SERVICE LETTER 281

Chine Replacement for 3000 & 3450 Floats

Figure 1 - Chine Extrusion

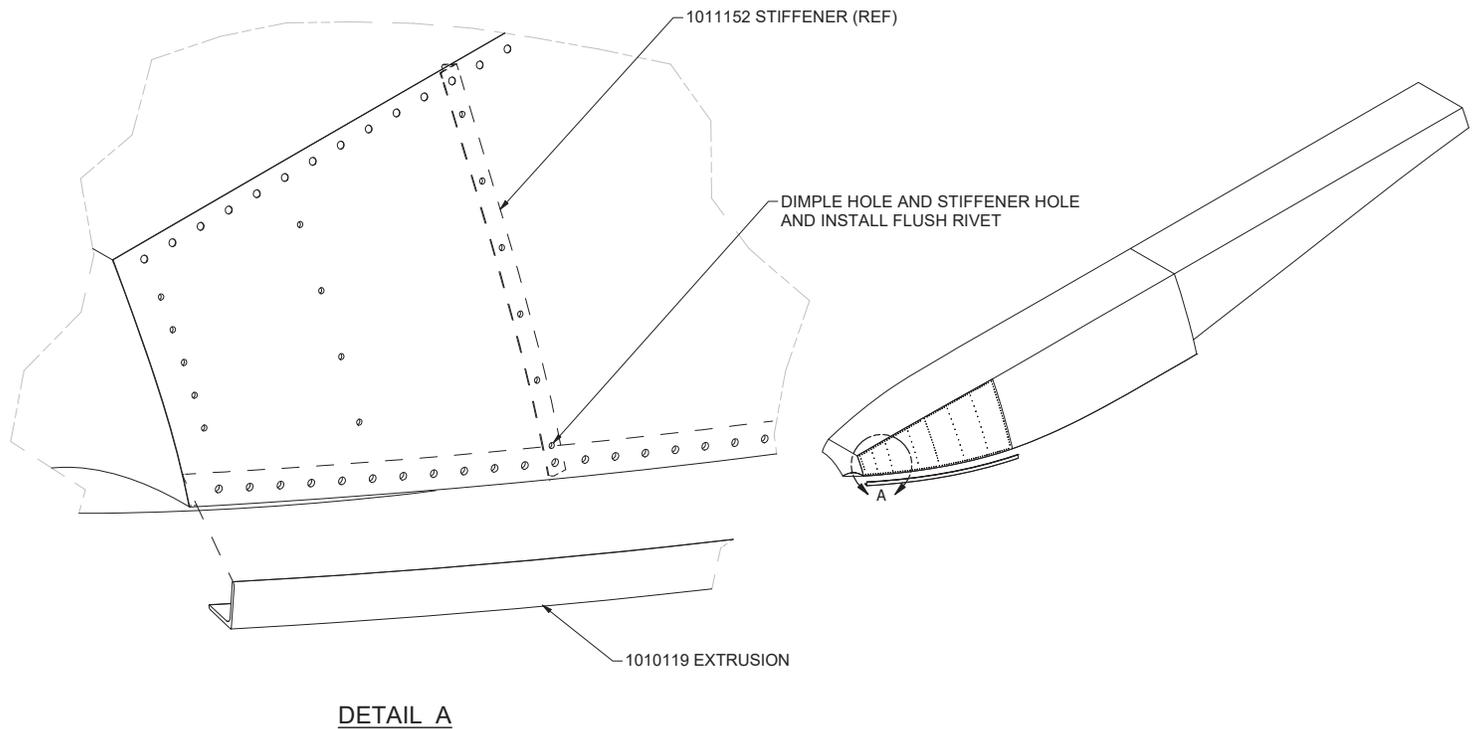
Wipaire has replaced the chine extrusions raw material on the 3000 floats and 3450 floats as a result of process and material consolidation. The former material is not considered deficient, but is no longer available. This service letter identifies a new raw material as an available replacement as needed, and highlights a conflict with a specific rivet location when transitioning from the old material to the new. For floats outside of the serial numbers above, refer instead to the latest revision of the corresponding Wipaire Parts Manual.

2. Install new chine extrusion while being careful not to back drill the rivet location indicated in Figure 1. The new material has longer profile legs which only partially cover this location.

1. Order new chine extrusion if desired.

ORDER PART INDIVIDUALLY AS NEEDED			
ITEM	QTY	PART NUMBER	DESCRIPTION
1	1	1010119	EXTRUSION, CHINE, FWD 6061T6 144" LONG (DIE 10626)
